| FED.ROAD DIST.NO. | STATE | PROJ. NO. | FISCAL YEAR | SHEET NO. | TOTAL SHEETS |
|---|---|---|---|---|---|
| HAWAII | HAW. | I-H3-1(72) | 1991 | ADD. 60 | 521 |

# GRADING PLAN
## H3 - KANEOHE INTERCHANGE
## STA. 333+62 TO STA. 344+00

# GRADING PLAN
## RAMP D
## STA.1083+57.76 TO STA. 1091+00

# GRADING PLAN
# RELOCATED LIKELIKE HIGHWAY
# STA. 0+00 TO STA. 9+00

ADD. 60

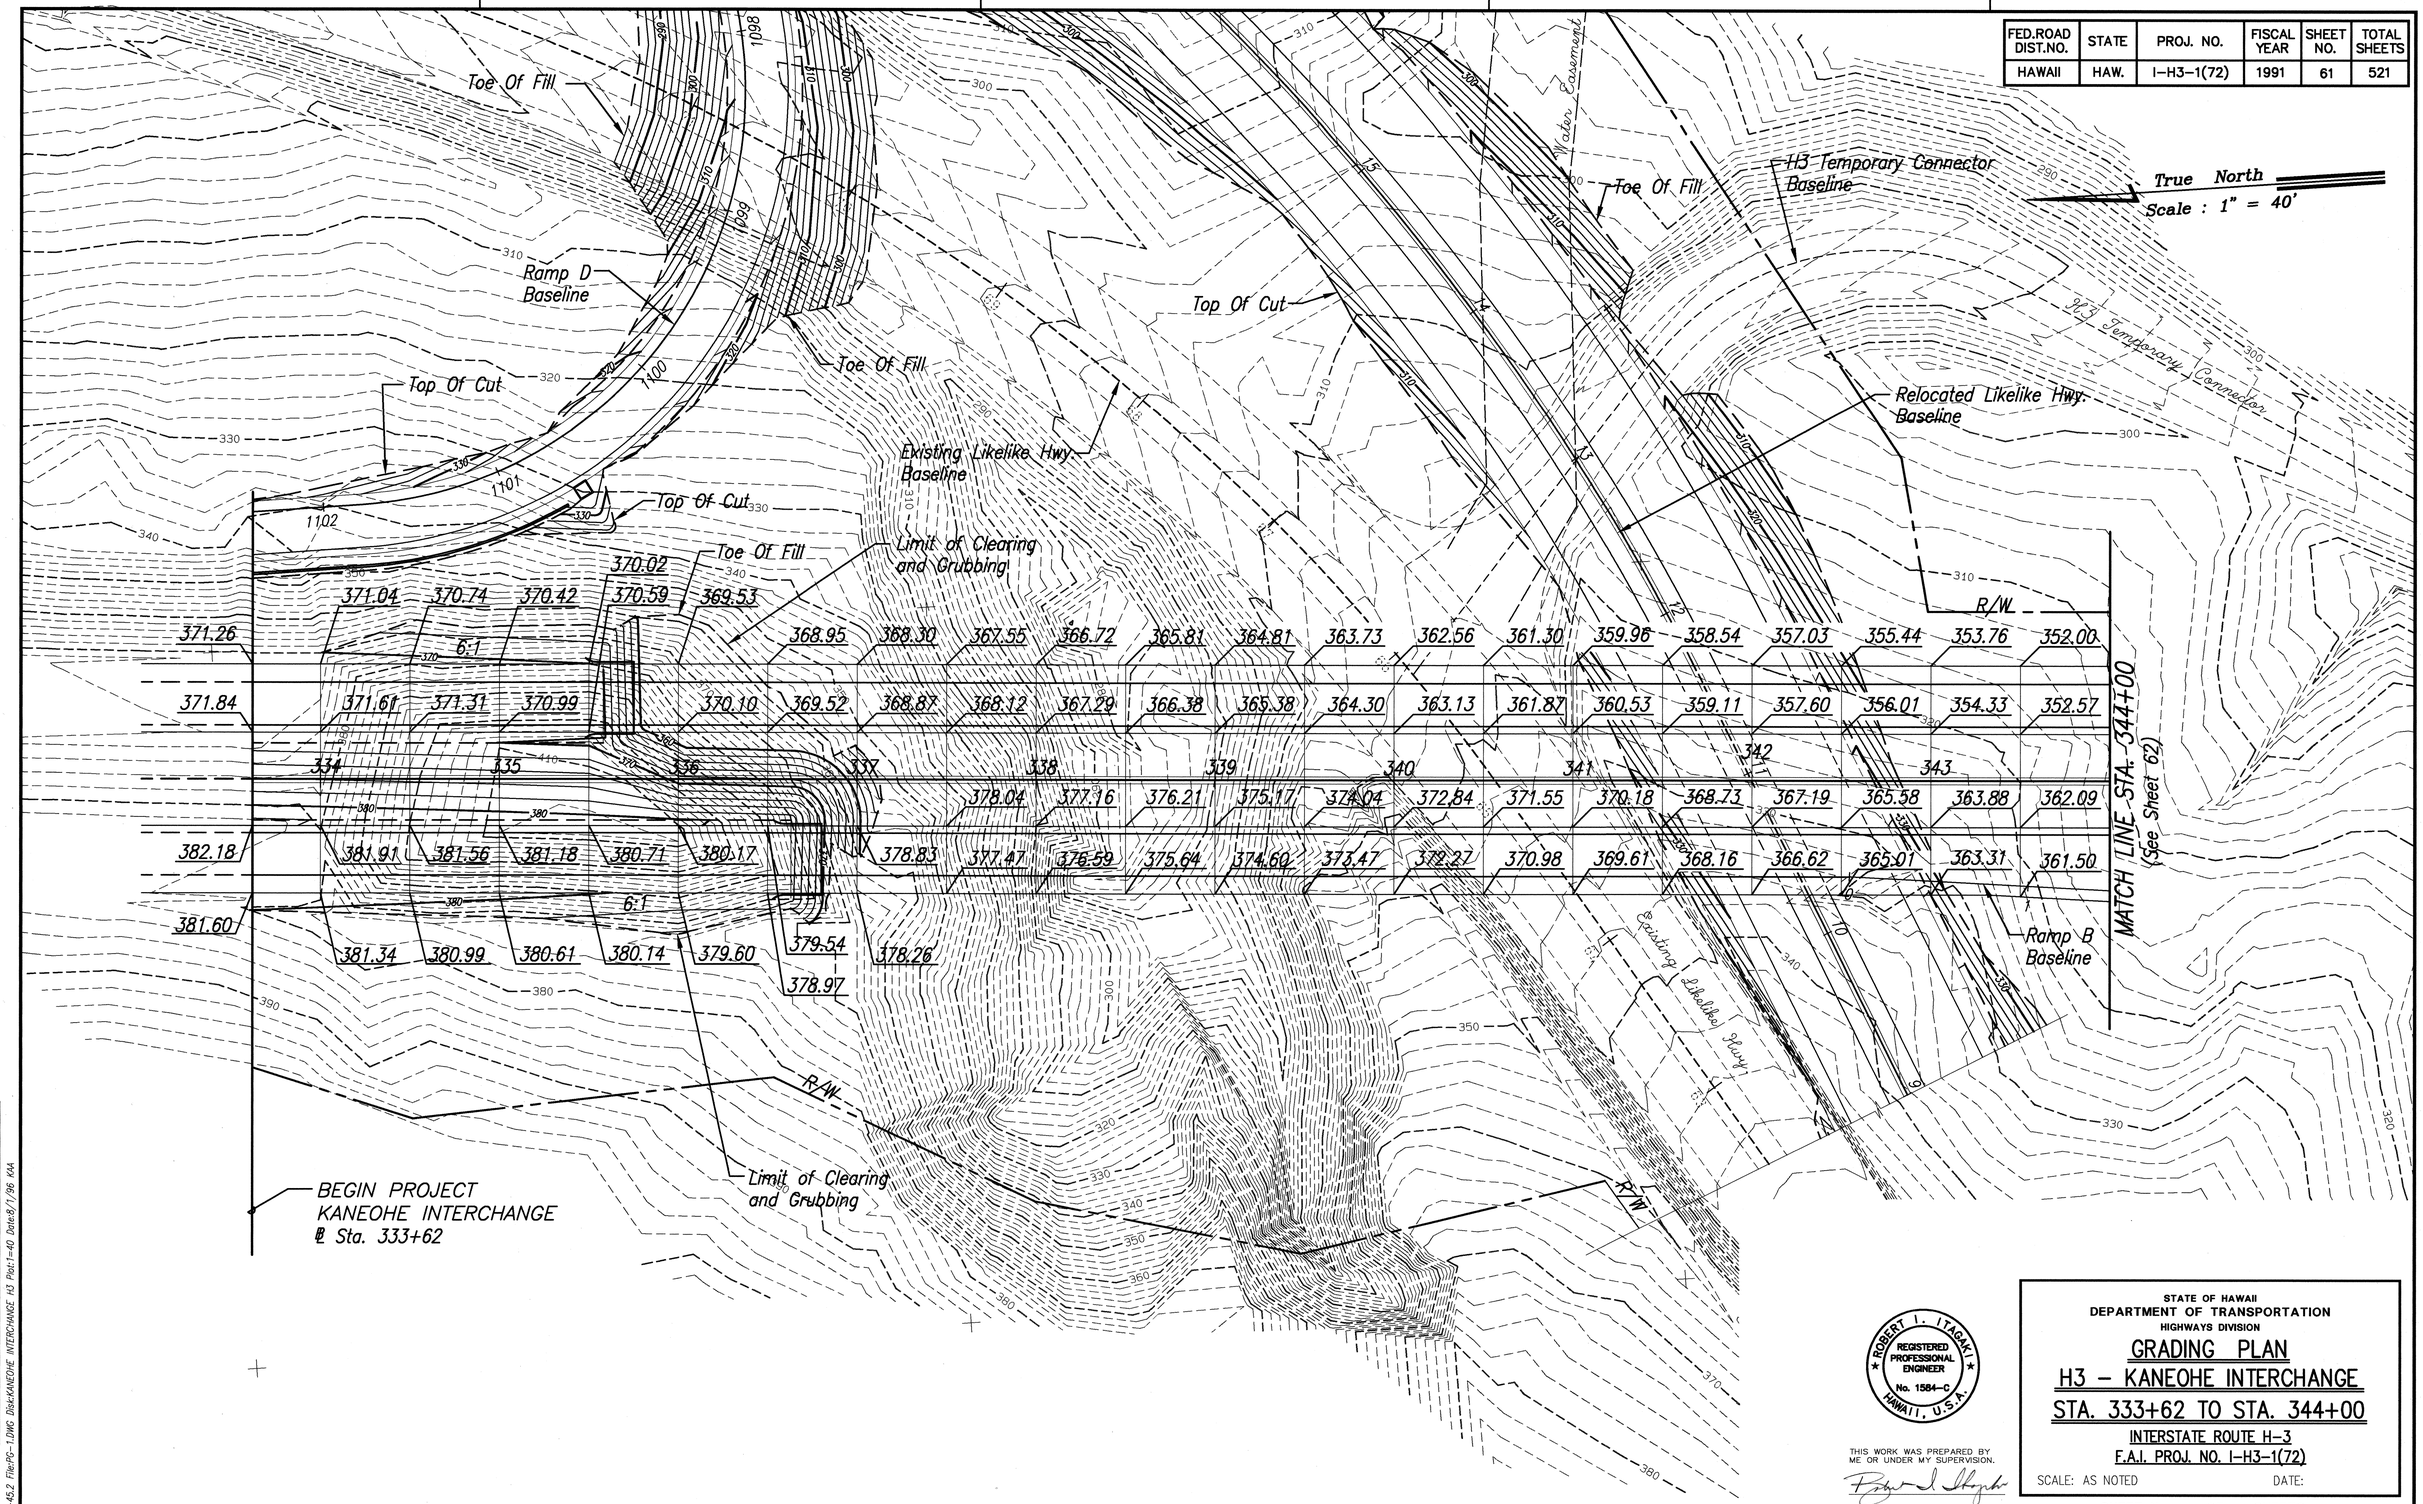
| DATE | REVISION |
|---|---|
| 3/27/92 | Revised Earthwork Quantities |
| 1/27/92 | Revised Grading Note 11 & 16 such that Contractor shall obtain grading permit. |

# GRADING PLAN
# RAMP B
# STA. 10+00 TO STA. 20+00

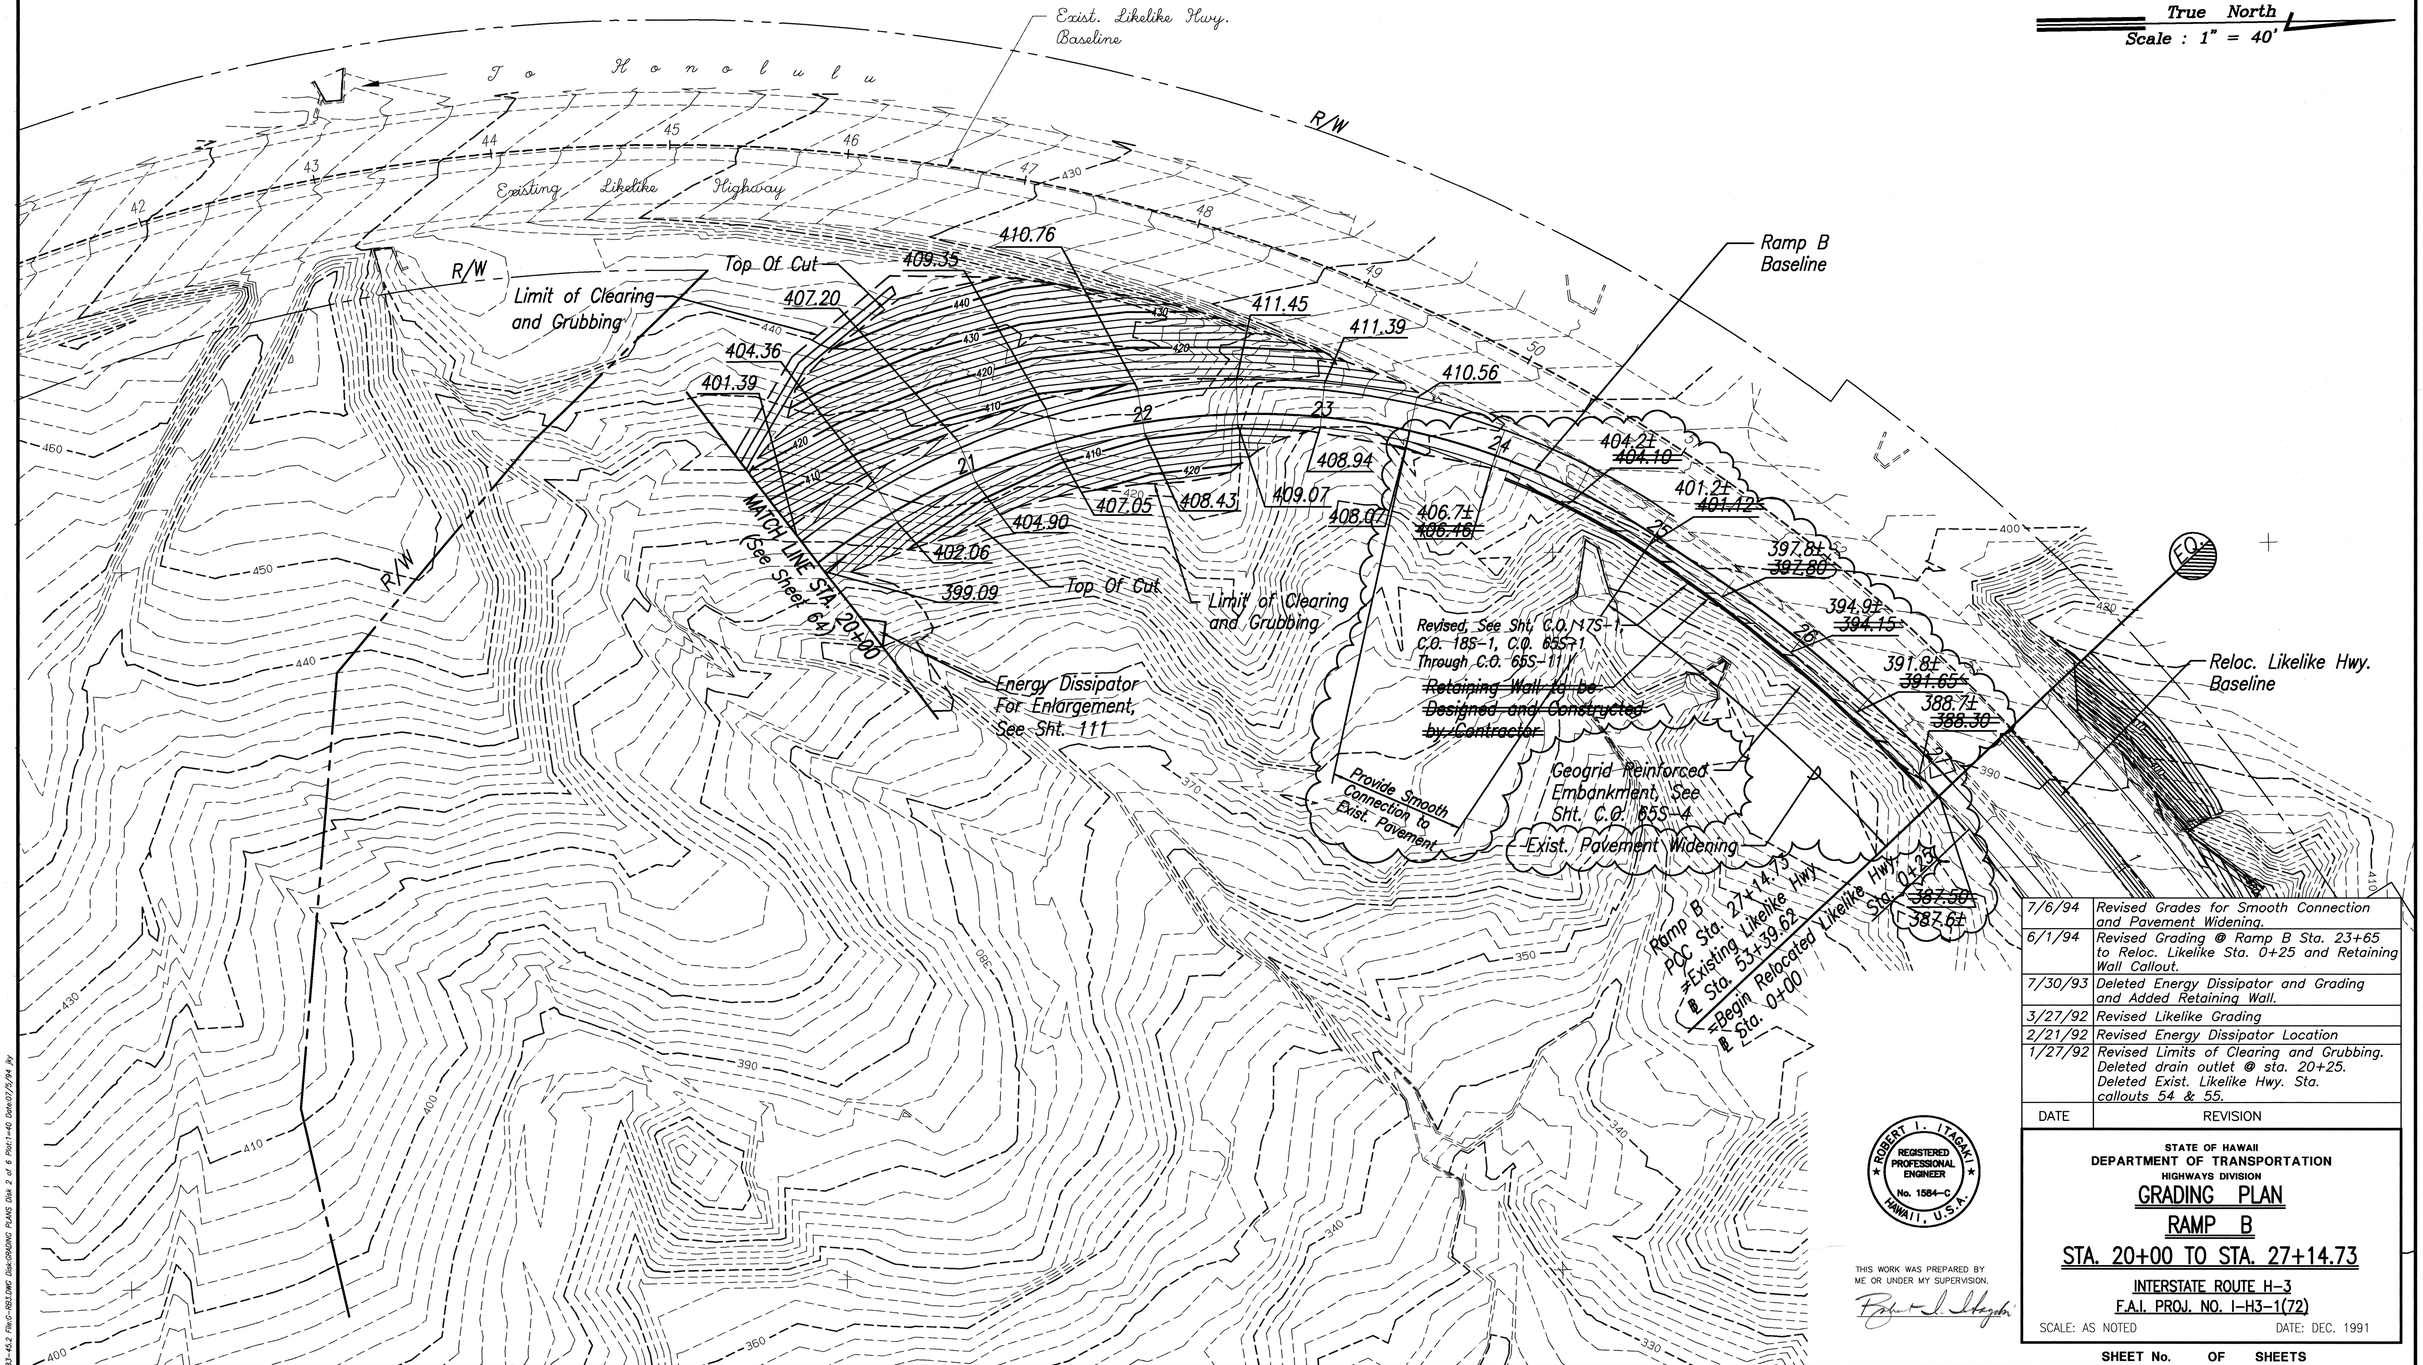
| DATE | REVISION |
|---|---|
| 12/1/92 | Added GRP at Abutment |
| 1/27/92 | Revised Limits of Clearing and Grubbing. Deleted drain outlet @ sta. 20+25. |

# GRADING PLAN
## RAMP D
## STA. 1102+00 TO STA. 1110+69.13

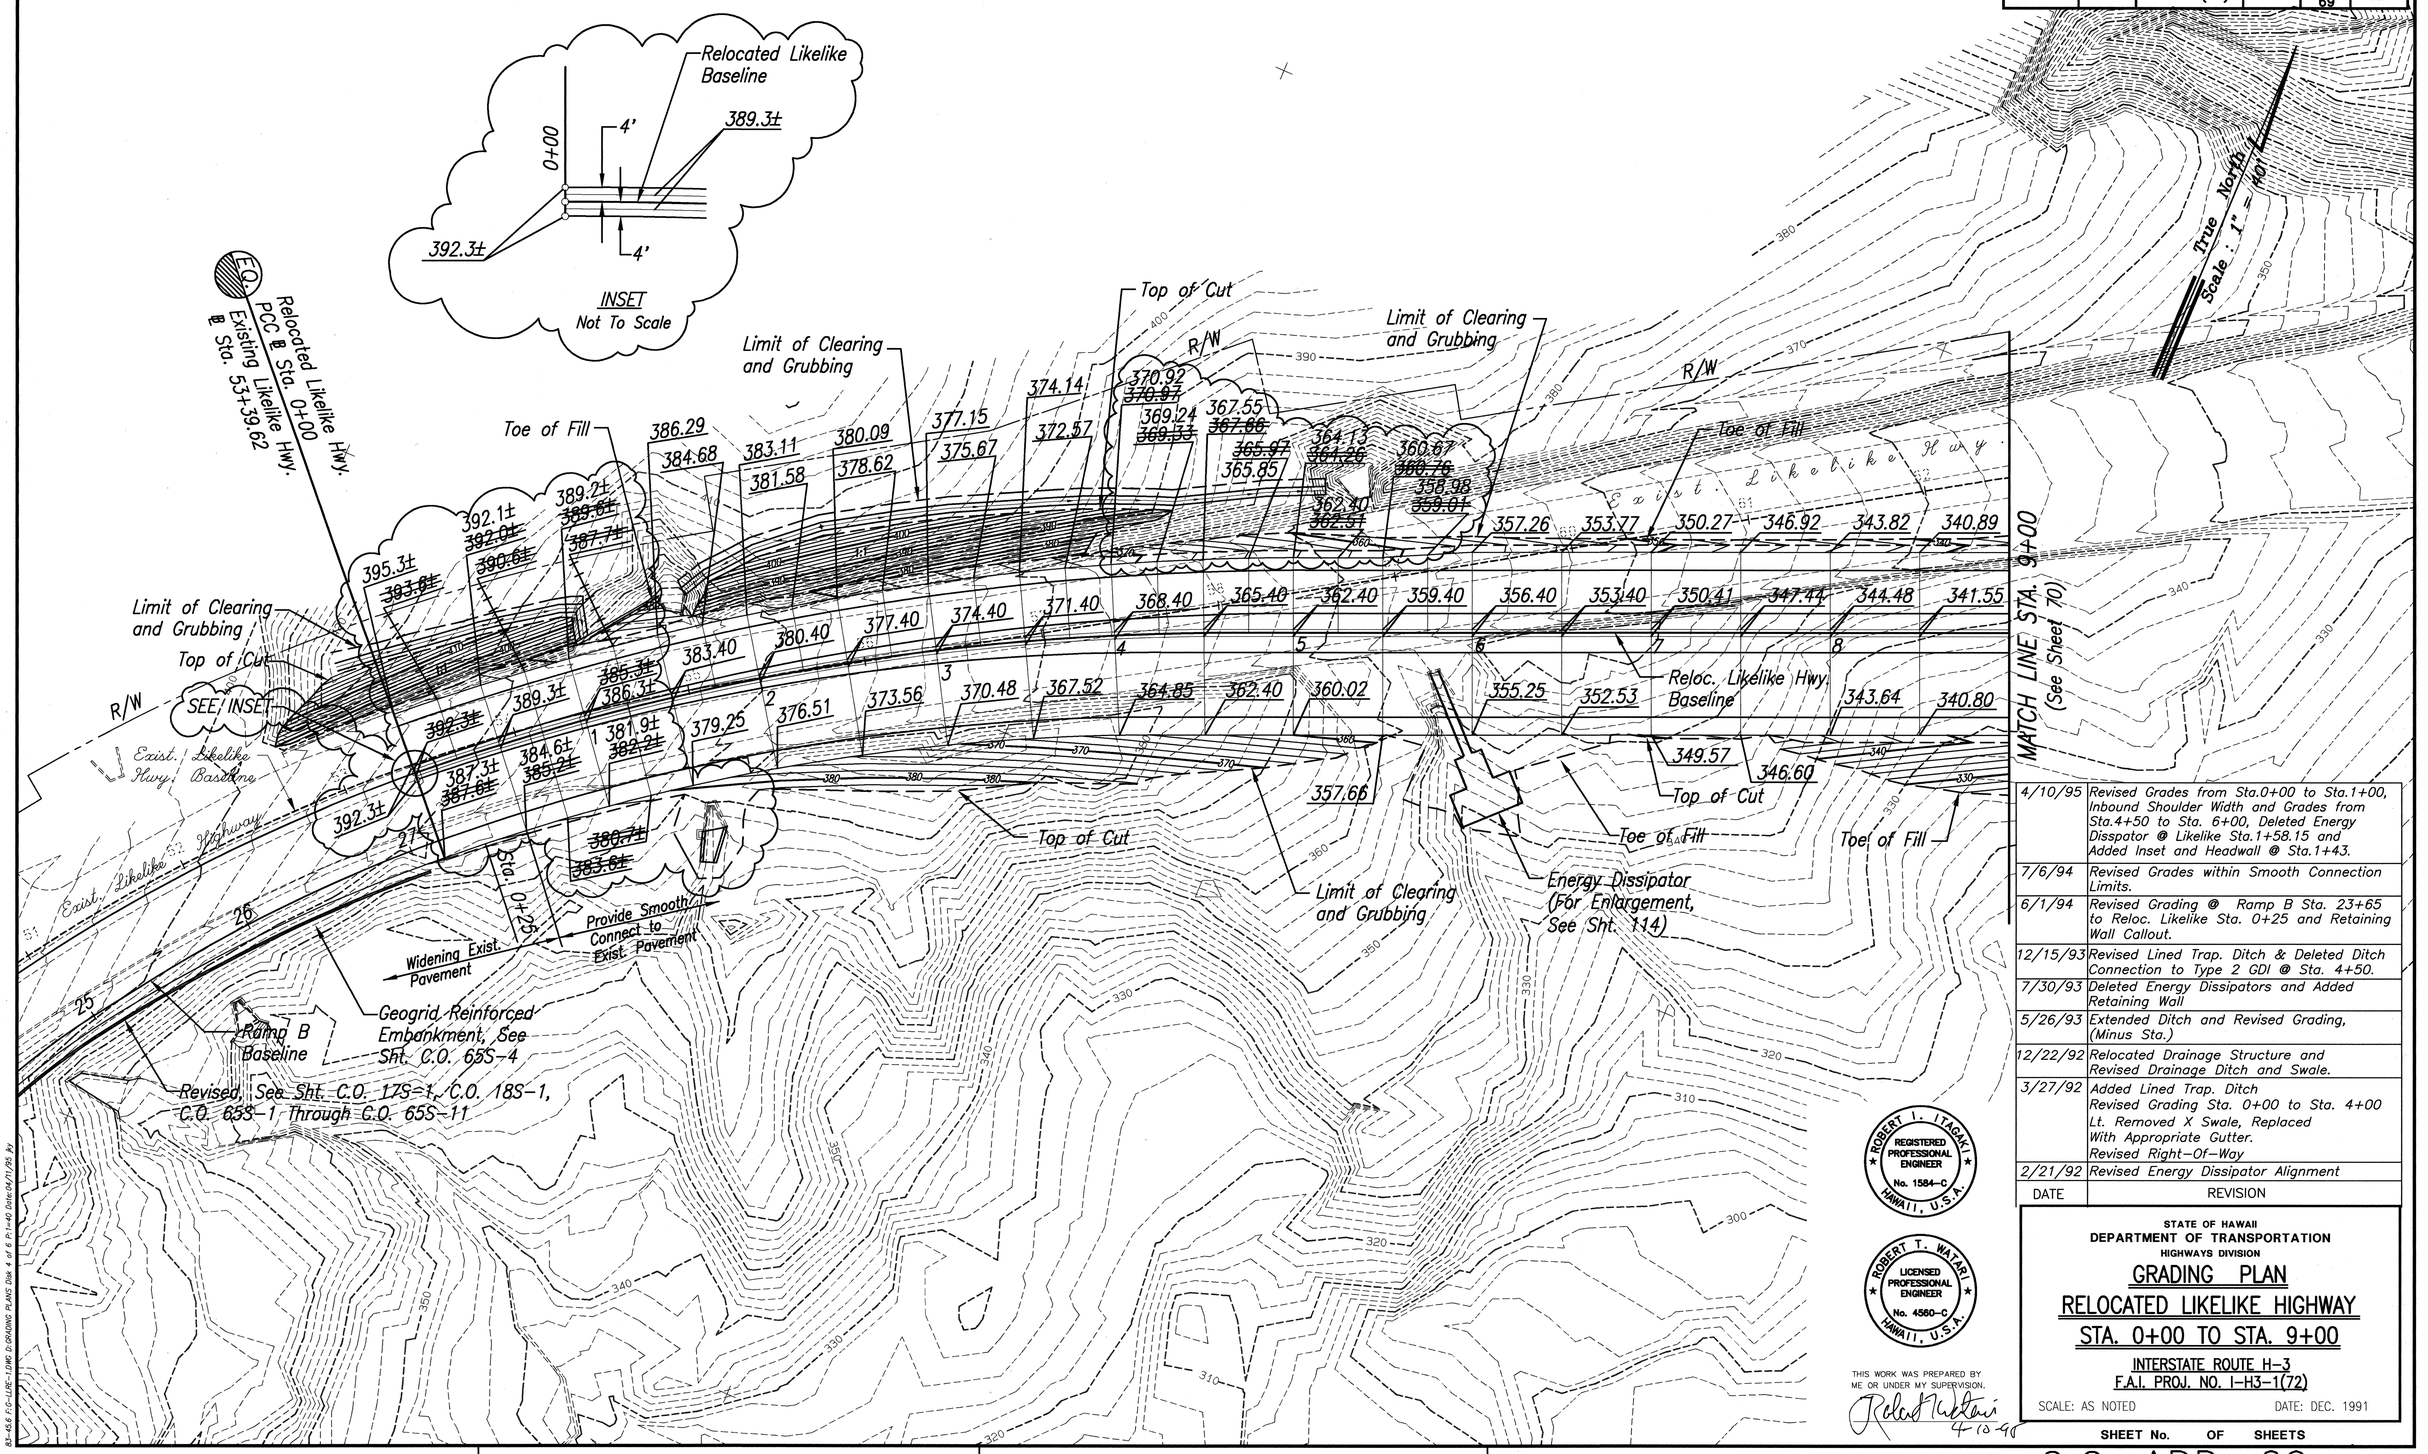
| DATE | REVISION |
|---|---|
| 3/1/95 | Revised Limits of Retaining Wall. |
| 9/15/93 | Added Enlargement: "RAMP D TRANSFORMER PAD ADDITION". |
| 3/27/92 | Revised finish grades @ Sta. 326+00 & 326+50. |
